To: Prospective Bidders  
From: Wold Architects and Engineers  
Date: July 30, 2014  
Comm. No: 133024

Subject: **Addendum No. 3** for Bidding Documents for the: **Courthouse Renovations Phase I & II**

This addendum forms a part of the Contract Documents dated July 3, 2014. Acknowledge receipt of this Addendum on the space provided on the Bid Form. Failure to do so may result in disqualification of Bid.

11. **SHEET M2.11 – MAIN LEVEL HVAC PLAN**  
A. Refer to attached Sheet M2.11 for revised manual volume damper locations.
12. **SHEET MP1.11 – MECHANICAL ROOM PLANS**

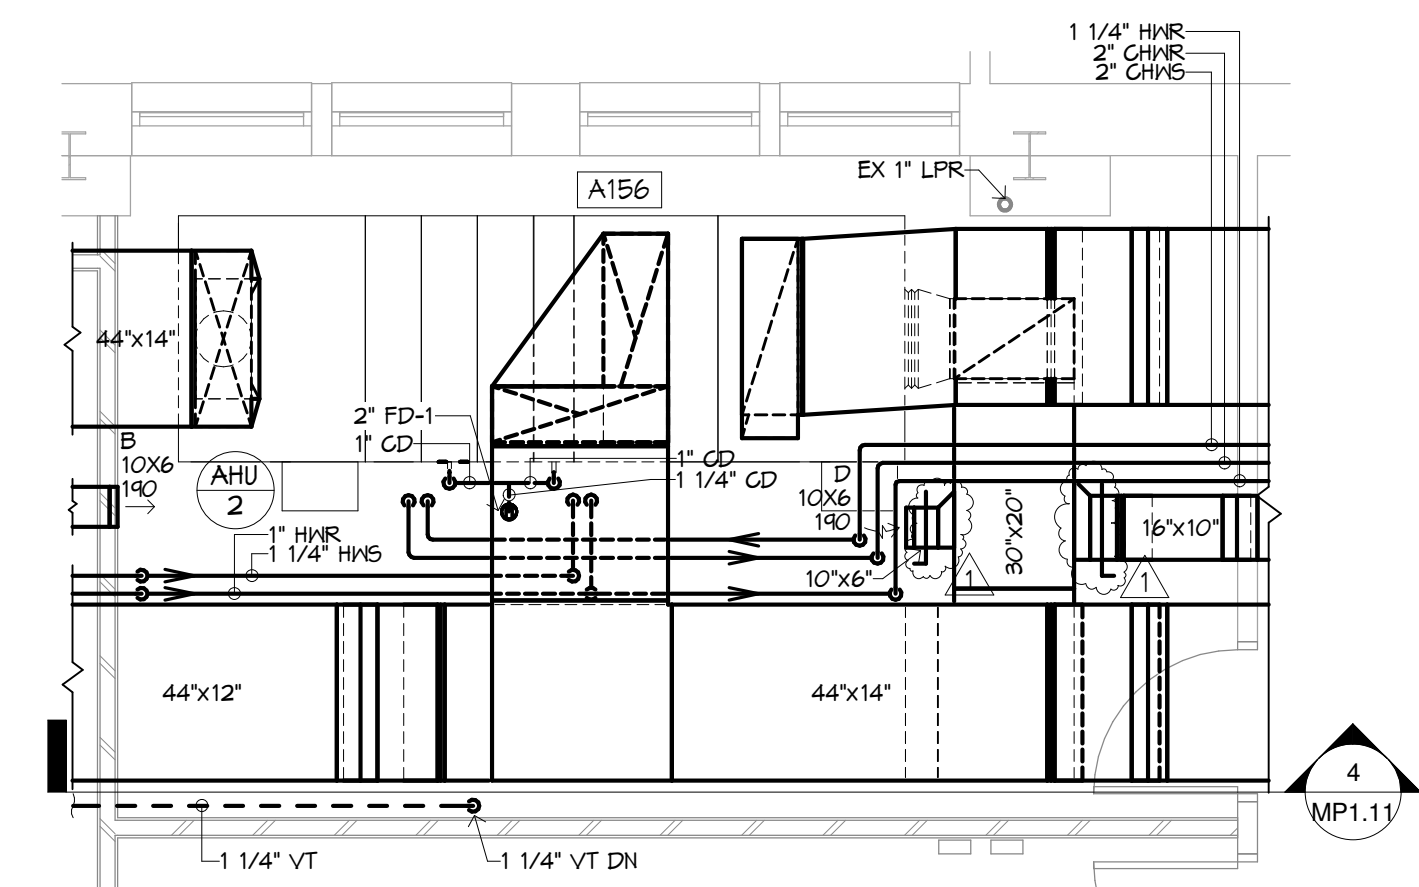
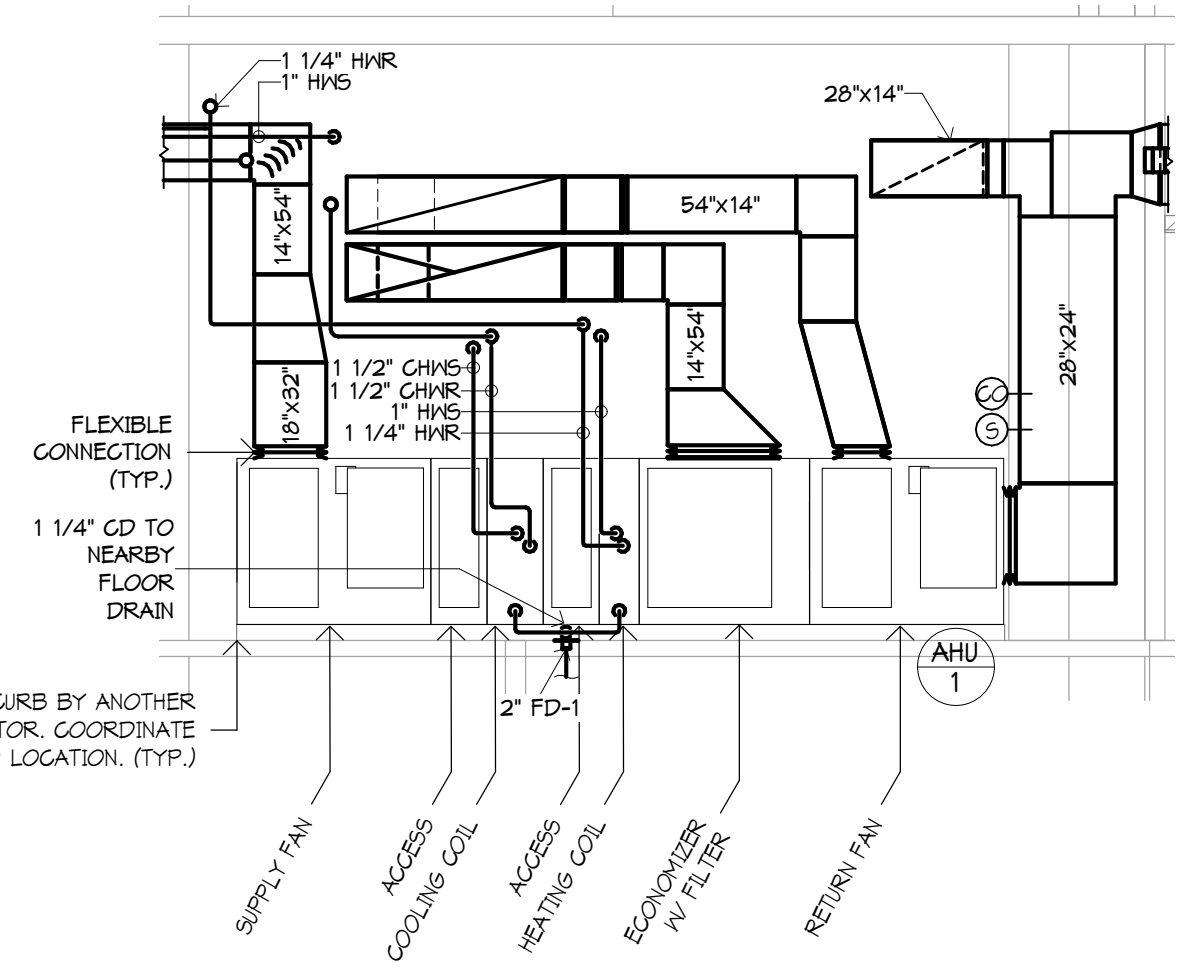
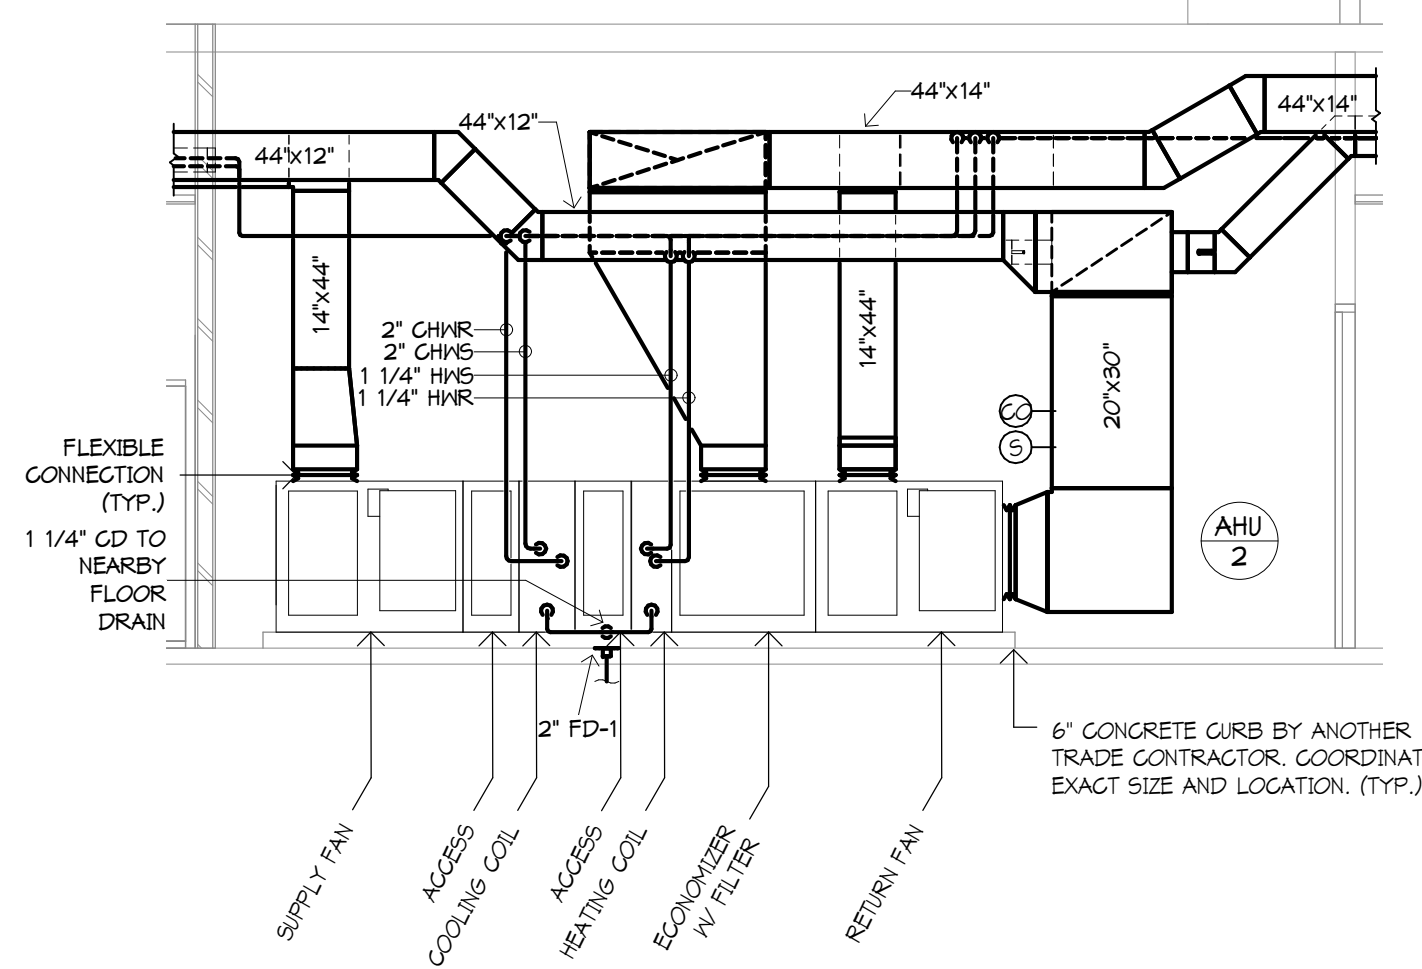
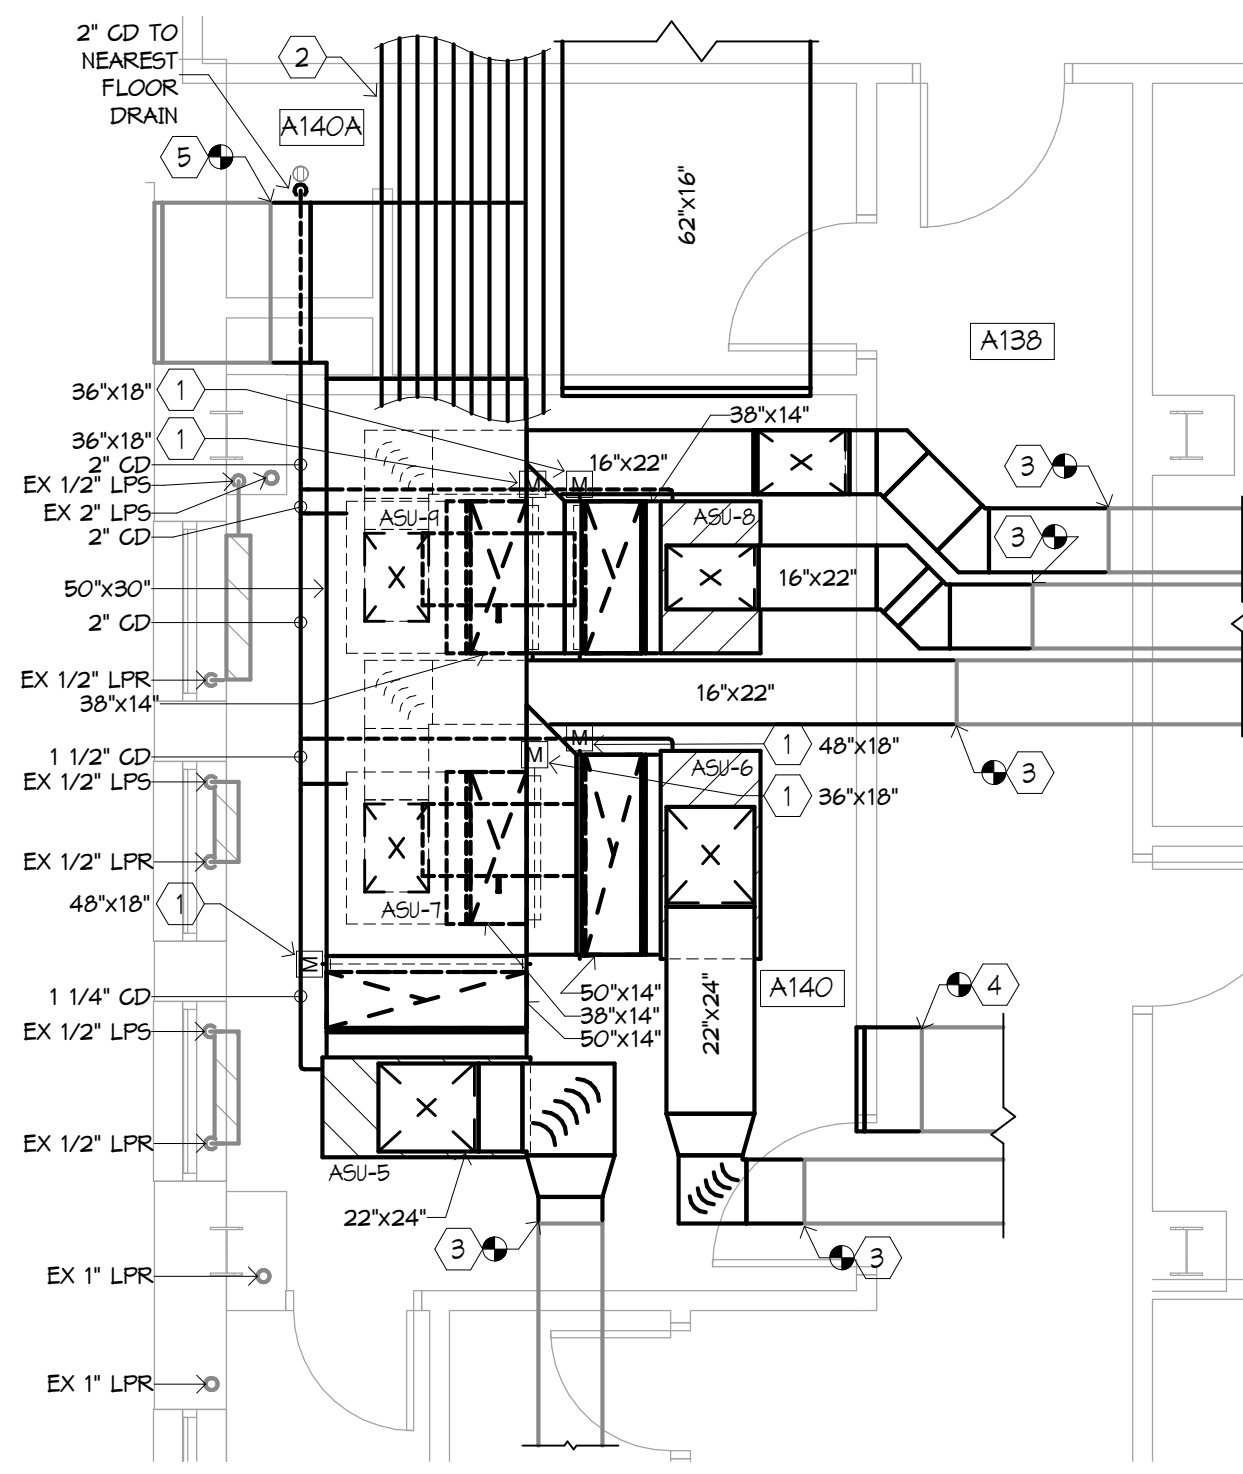
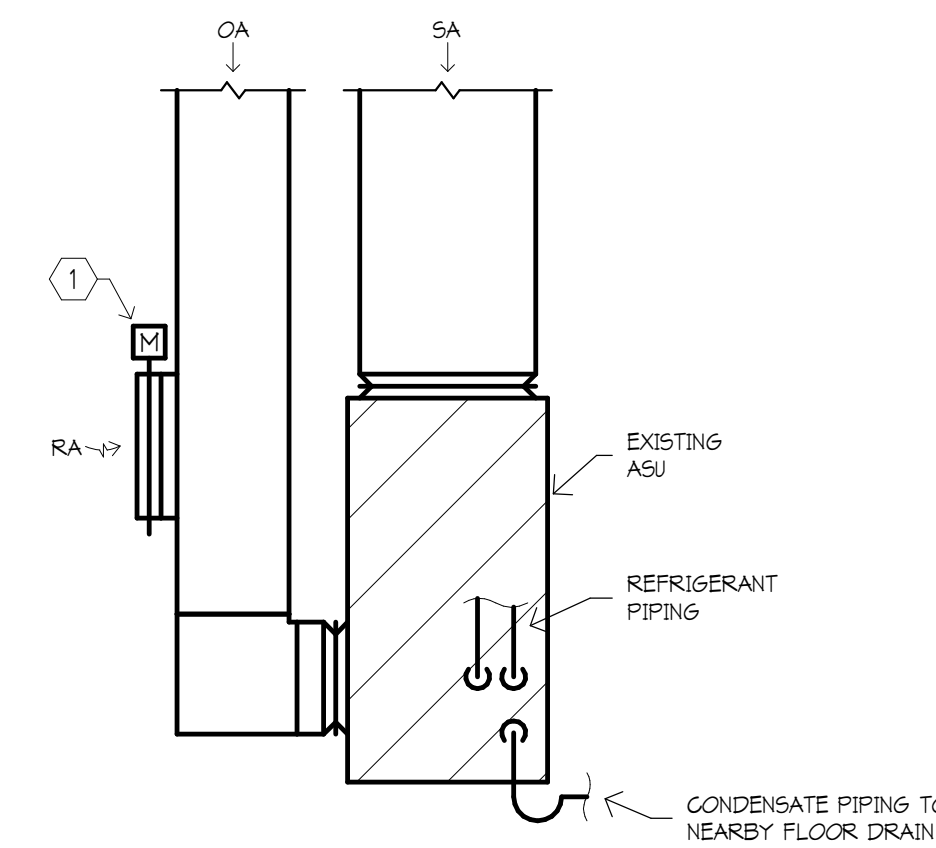
A. Refer to attached Sheet MP1.11 for revised manual volume damper locations.
13. **SHEET E1.1 – MAIN LEVEL ELECTRICAL DEMOLITION PLAN**  
A. Refer to attached Sheet E1.1 for revisions this Addendum.
